DRAWER		EE	DATE	POWER	DATE	INVENTEC DAVOS-DF
DESIGN						
CHECK						
RESPONSIBLE						
SIZE = 3		VER :		SIZE A3	CODE CS1	
FILE NAME : XXXX-XXXXXX-XX				DOC. NUMBER PC9603		REV A01
P/N : XXXXXXXXXX		SHEET 1		OF 65

IEC / HP Davos 1.0 Schematic Changes					PV-1			
HP Confidential Information						Last Updated: October 28, 2004		
Item #	Component / Subsection	PG. #	Description of Requested Change	Date Open / Closed	Requested By	Status	IEC FBK/Date	
1	ITP Conn (CN22)	19	Zone C6. Add 0.1uF no install capacitors pads to the following traces: H_TMS H_TCK H_TDO H_TRST# ITP_DBRESET Place the pads as close to the ITP conn as possible and keep the stubs as short as possible.	2004/9/17	BR	Open	Zone C6. Add 0.1uF no install capacitors pads to the following traces: H_TMS(C5003) H_TCK(C5004) H_TDO(C5005) H_TRST#(C5006) ITP_DBRESET(C5007) Place the pads as close to the ITP conn as possible and keep the stubs as short as possible.	
2	Alviso	22	Zone C6. Add 0.1uF no install capacitor to H_CPURST#. Place the pads as close to Alviso as possible and keep the stubs as short as possible.	2004/9/17	BR	Open	Add C5008 to H_CPURST#. But there is no place can put the pad close to Alviso, so that put it close

TITLE
DAVOS-DF
6 IN 1 SLOT

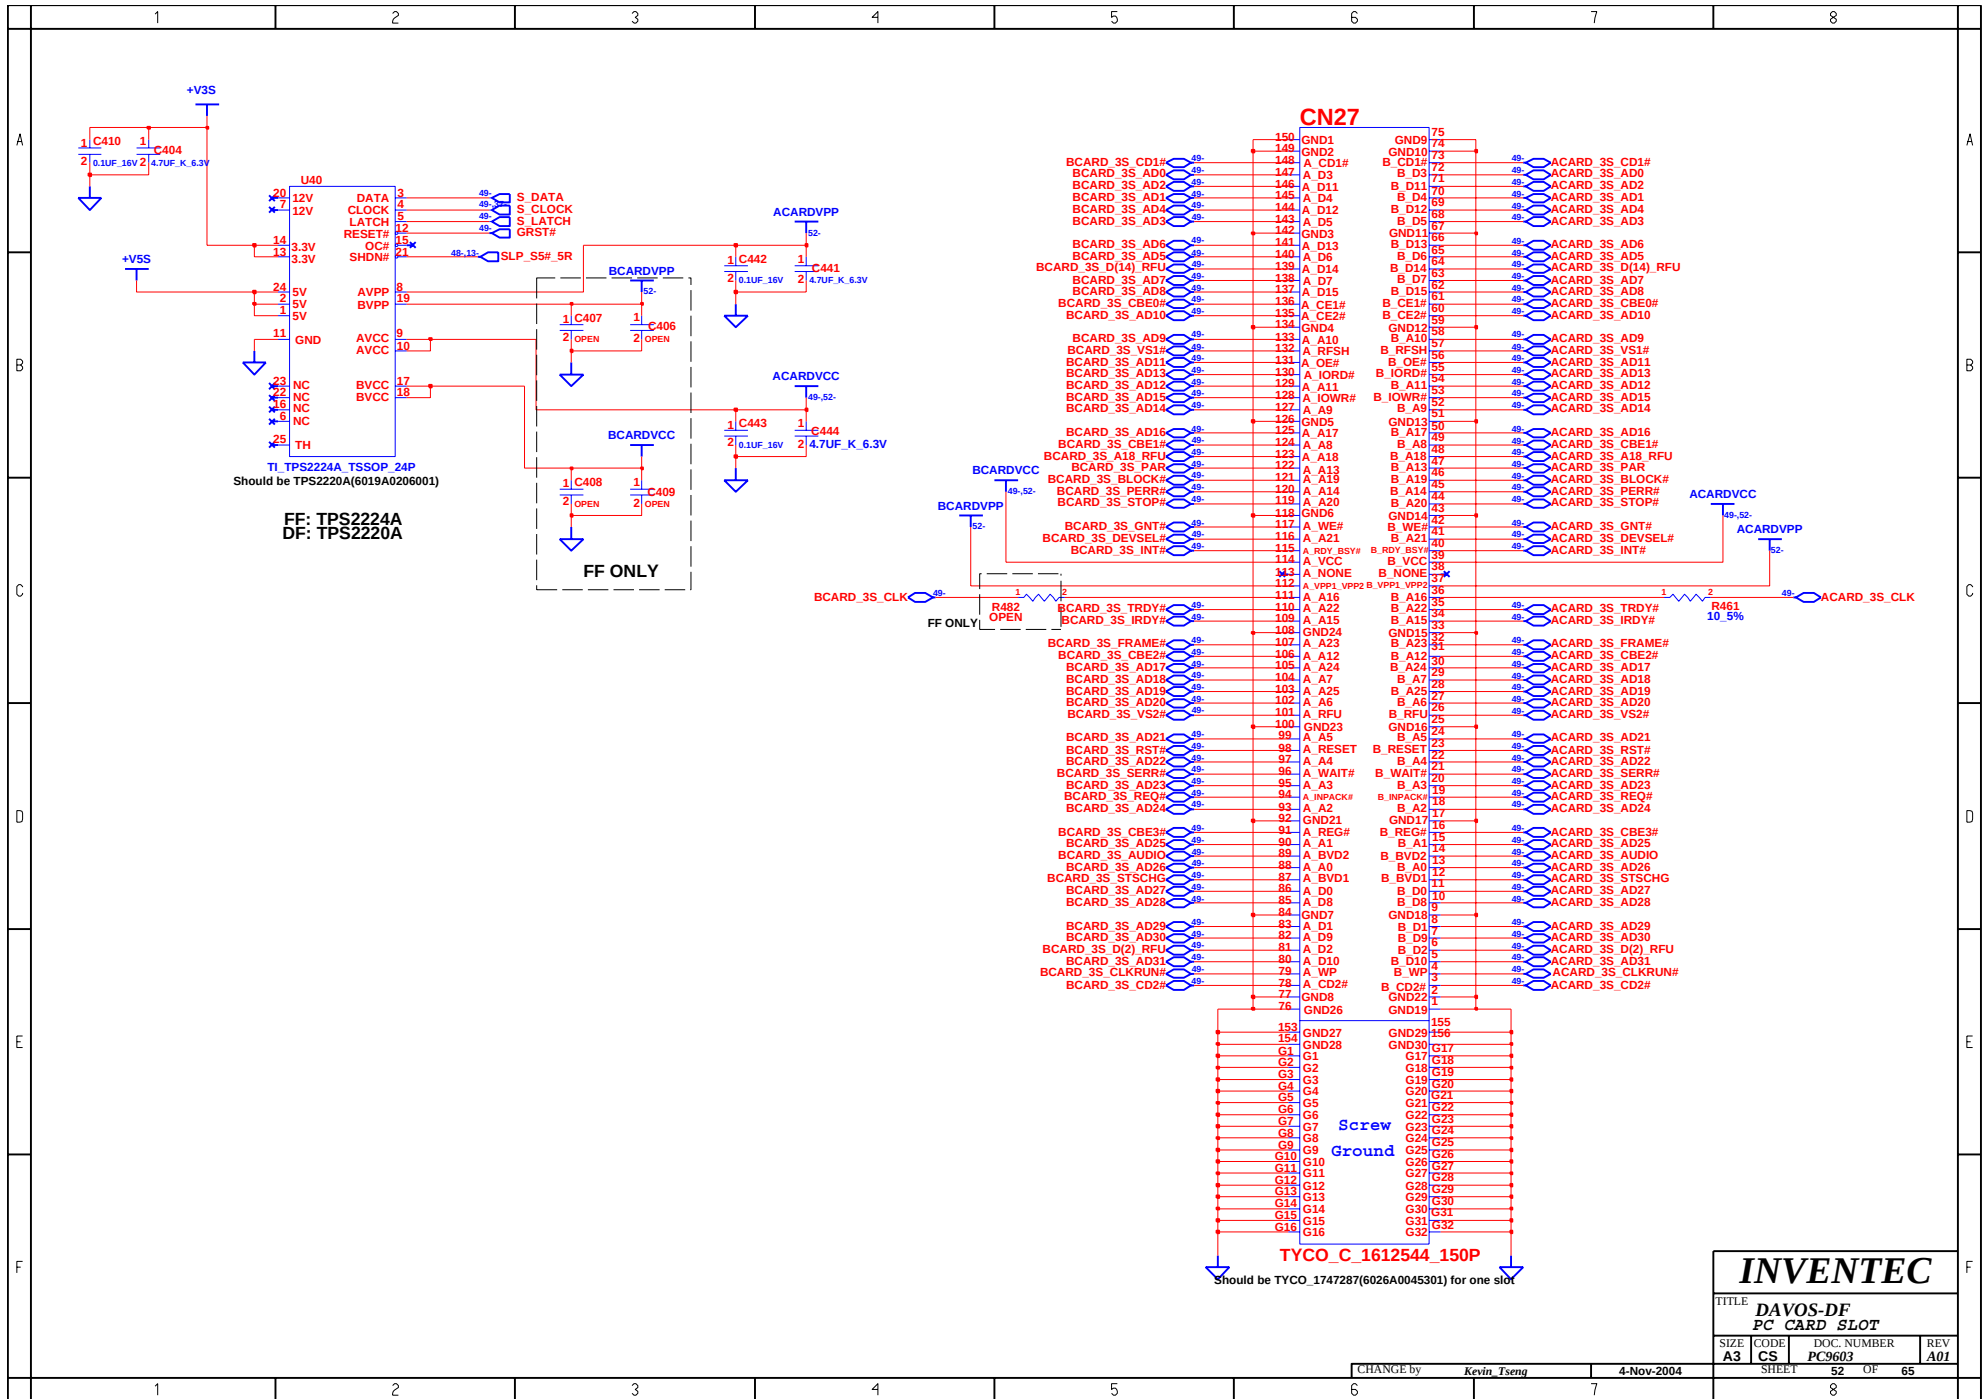
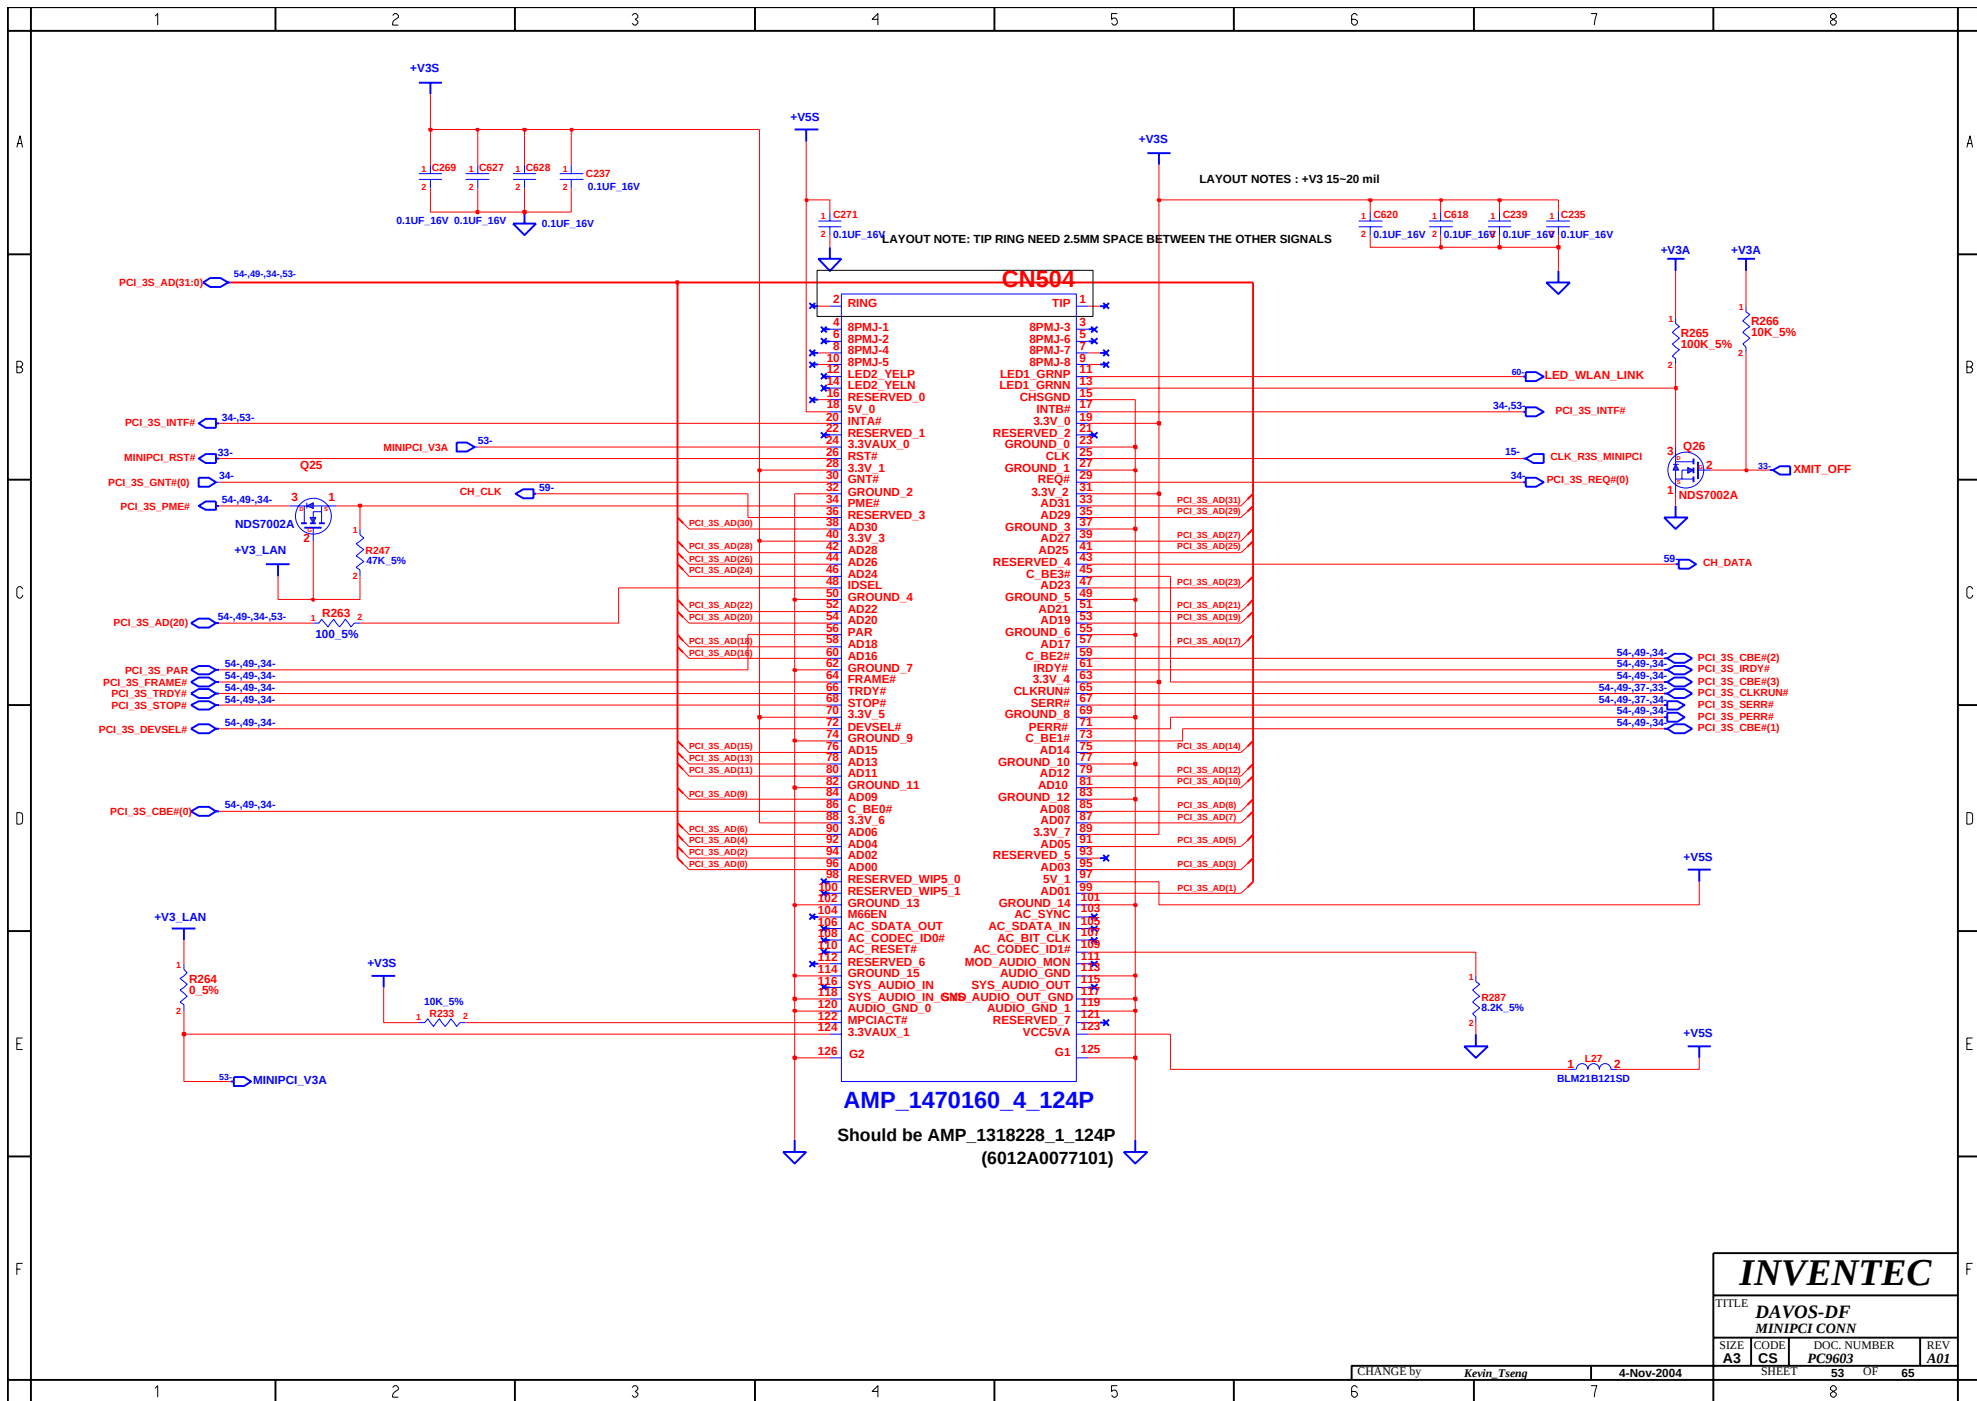
3	Wireless button	63	Zone F3, Delete pin2 & 4 of SW2 to ground, made it to NC.	2004/9/27	IEC	Open	Fixed in 0927.	
4	6 in 1	50	Change pin2&3 of U42, pin1 of R720 to from +V5S to +V3S.	2004/9/27	IEC	Open	Fixed in 0927.	
5	6 in 1	50	Zone D6, Exchange pin define of CN5001, pin20, pin21.	2004/9/27	IEC	Open	Fixed in 0927.	
6	Power	11	Zone B4, Change C198 to 4.7uF_6.3V-for GSM interference issue.	2004/9/27	IEC	Open	Fixed in 0927.	
7	Thermal	20	Zone D5, Change C290 to 4.7uF_6.3V-for GSM interference issue.	2004/9/27	IEC	Open	Fixed in 0927.	
8	CRT	30	Zone C1, Add three analog bus switches to the RGB lines going to the notebook CRT connector.	2004/9/17	HP	Open	Zone C1, Add three analog bus switches(U2001, U2002, U2003) to the RGB lines going to the notebook CRT connector.	
9	CLK gen	15	Zone C3, Change CLK_R3S_CBPCI from pin5(PCI5) of U30 to pin56(PCI2), Separate CLK_R3S_SIOPCI and CLK_R3S_FWHPCI from pin4(PCI4), and connect CLK_R3S_SIOPCI to pin5(PCI5) of U30.	2004/10/4	IEC	Open	Fixed in 1004.

TITLE
**DAVOS-DF
NIC - TRANSFORMER**

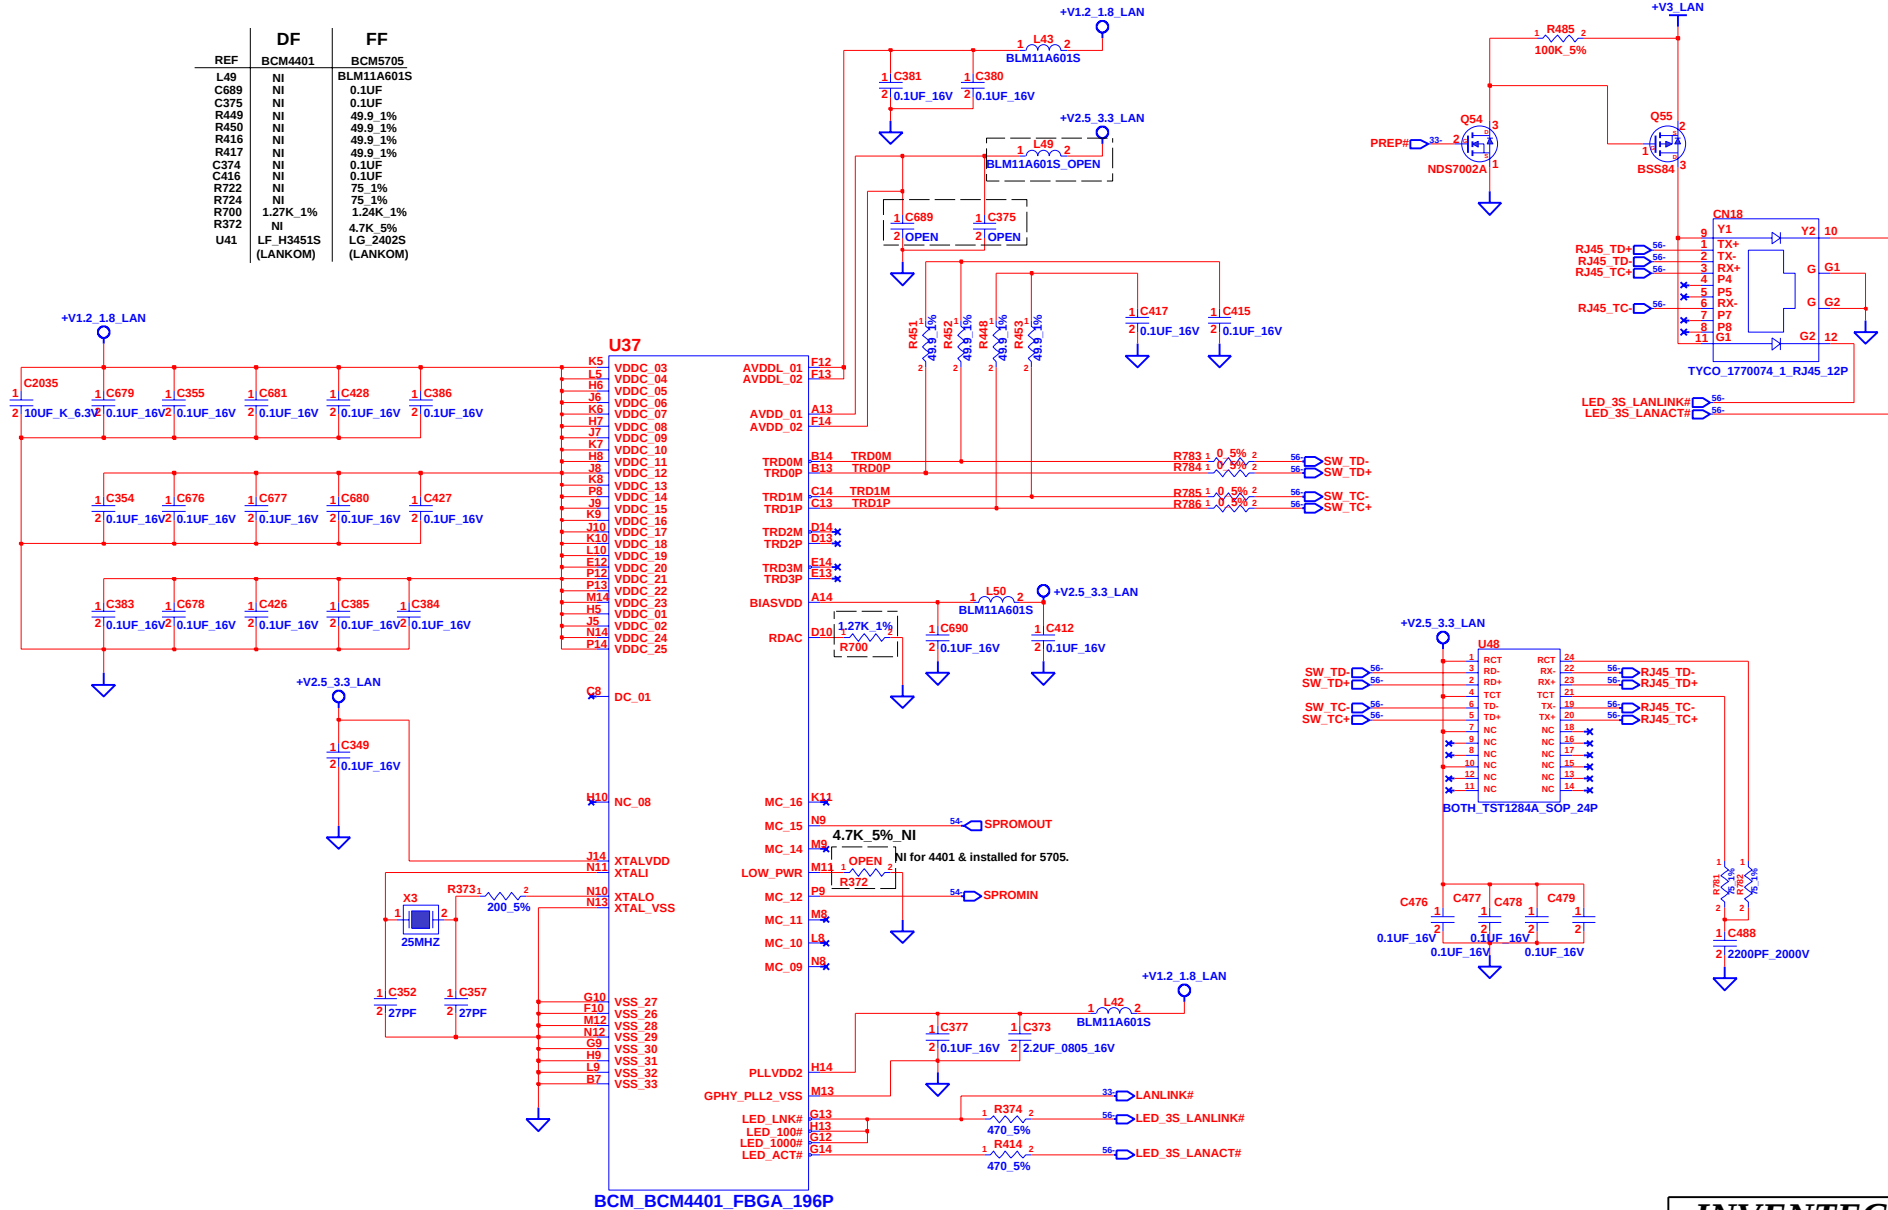
17	NIC	56	Zone E8, Remove CN28 for lan signal to docking going to on board.	2004/10/8	IEC	Open	--Fixed in 10/08.
18	NIC	57	Zone E8, Remove CN10 for lan signal to docking going to on board.	2004/10/8	IEC	Open	--Fixed in 10/08.
19	All	All	Change reference, C5003->C713, C5004->C714, C5005->C715, C5006->C716, C5007->C717, C5008->C718, U2001->U512, U2001->U512, U2002->U513, U2003->U514.	2004/10/8	IEC	Open	--Fixed in 10/08.
20	Power	7	Add 1000pf cap(C719). from R743p1 to GND Add .1uf cap(C720). from U510p2 to GND Add 220k(R776) from U509p1 ()to U509p3. Disconnect V3AL_OFF# from U510p7 Disconnect Q533p3 from R742 Add NFET(Q534), tie gate to Q533p1, drain to Q533p3 and to V3AL_OFF#, and source to R742p2 & U510p1. Change U509 to MIC5235 Change R740 to 30.1k	2004/10/9	HP	Open	Issue was discovered with U510 pg7 in which it could begin to oscillate pulling down +V5AL prohibiting the system from booting. --Fixed in 10/11 schematic.
